Stage 5: Draft Final Modification Report		At what stage is this document in the process?												
<h1 style="color: #00a651;">GC0096</h1> <h2 style="color: #00a651;">Modification Title: Energy Storage</h2>

<table><tr> <td style="width: 20px;">01</td> <td>Proposal Form</td> </tr><tr style="background-color: #00a651; color: white;"> <td>05</td> <td>Draft Final Modification Report</td> </tr></table>

This document is the Draft Final Modification Report that contains the discussion of the Workgroup which formed in May 2016 to develop and assess the proposal, the responses to the Workgroup Consultation which closed on 11 January 2019, the voting of the Workgroup held on 13 March 2019 and the first Code Administrator Consultation responses. The Panel reviewed the Workgroup Report at their Grid Code Review Panel meeting on 25 April 2019 and agreed that the Workgroup had met its Terms of Reference and that the Workgroup could be discharged. This document also contains the responses to the second Code Administrator Consultation that closed on the 18 November 2019.

Figure 2

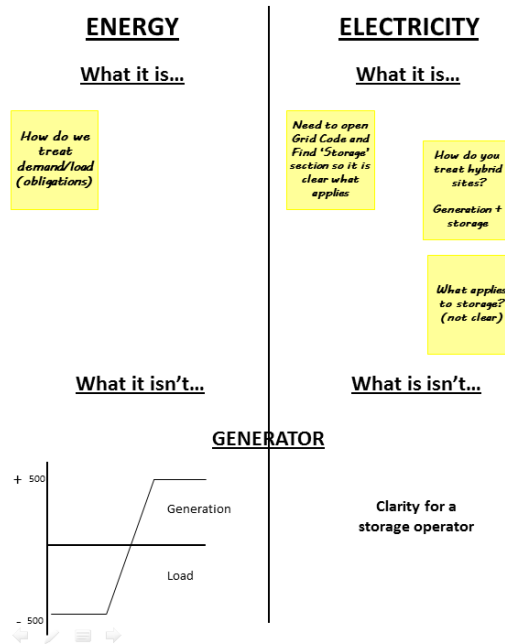
It was noted by the Proposer that at the two workshops in August 2016, industry developed an initial thought on a definition for Electricity/Energy Storage which can be seen in figure 2 below. Following a Workgroup debate, the Workgroup determined that the correct definition to use was 'Electricity Storage' and that any definition should be technology neutral and setting a minimum standard noting that users can exploit their full operational flexibility through commercial services arrangements/ markets (e.g. Enhanced Frequency Response).

At the third Workgroup meeting, a Workgroup member voiced an important clarification. Added to the definition for Electricity Storage was the ability for the Storage Facility Owner to be able to *control* the ‘conversion’ and ‘reconversion’ of that electrical energy – an important clarification to ensure a sufficient level of response to system-need for the technologies in question.

Figure 2.0

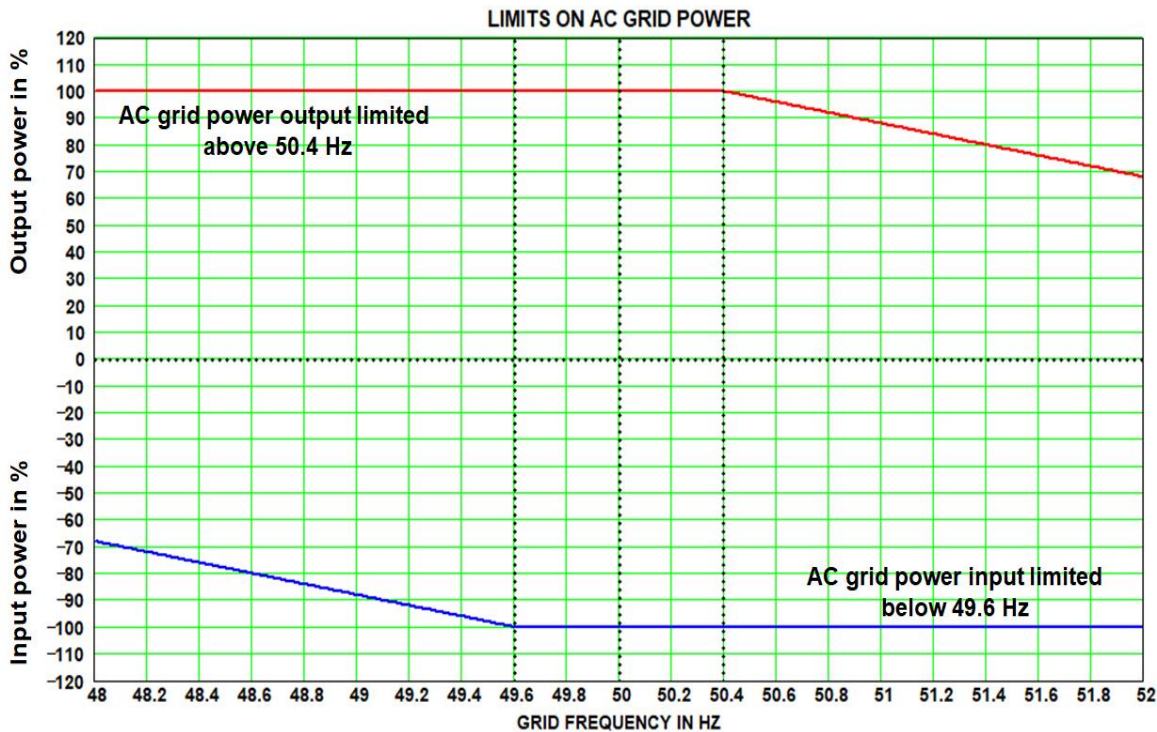
As part of the Workgroup discussions, one Workgroup member noted that storage should have a requirement to cater for limiting power input with falling frequency and limiting power output with rising frequency and proposed the use of the following graph.

The Proposer would however note that the characteristic shown in Figure 2.0 may be more appropriate however as also pointed out by a workgroup member this requirement applies to generation equally as it applies to Storage. As such, and as the aim of the workgroup is to ensure consistent treatment between different classes of User's, this is an issue that should be highlighted as a future area of work as the implications of a change to generation affects a much greater audience.

Figure 3.0 (a)

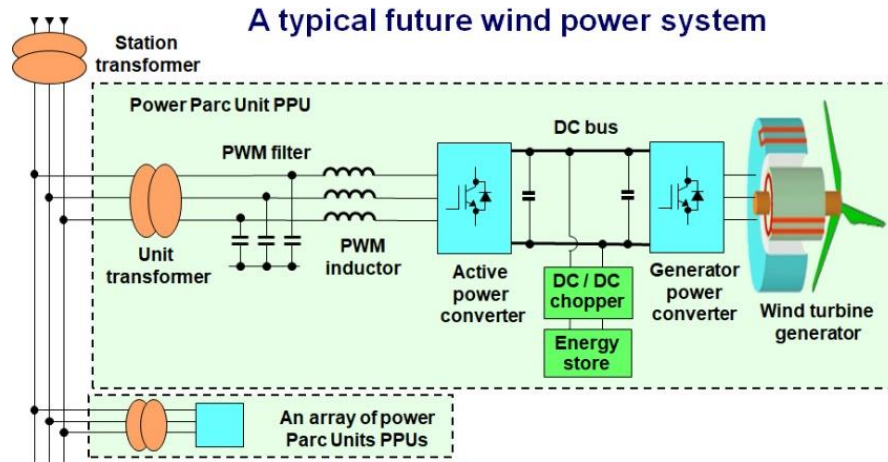
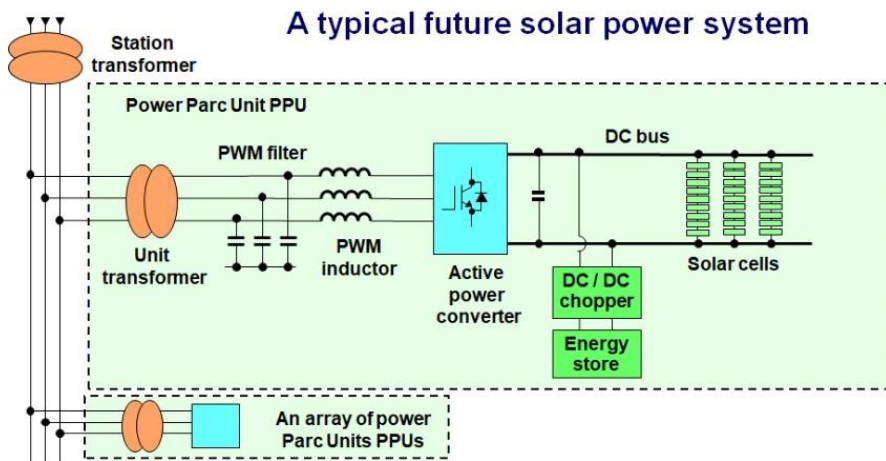
In addition, a Workgroup Member noted that as part of a future co-located site that it was entirely likely that an energy storage technology could be integrated as part of a solar park, wind farm or synchronous plant. Figure 3.0(a) and Figure 3.0(b) below (which have

One Workgroup member noted that for wind farms and solar parks, the storage elements are not directly connected to the AC system and raised concern that they would not be required to satisfy the requirements of the GC0096 proposals. It was also noted that for rotating synchronous generators this is not so much of an issue.

In response, the Proposer would note that where you have a Power Station comprising of Power Park Modules and/or Electricity Storage Modules, the Grid Code applies to the Power Park Modules and Electricity Storage Modules within that Power Station.

In addition, the Proposer would note that as part of the GC0096 proposals, that when a storage element is operating in a condition analogous to demand, then there is a requirement for this demand to be reduced as frequency falls as defined under OC6.6, in just the same way as pump tripping as part of a pumped storage plant.
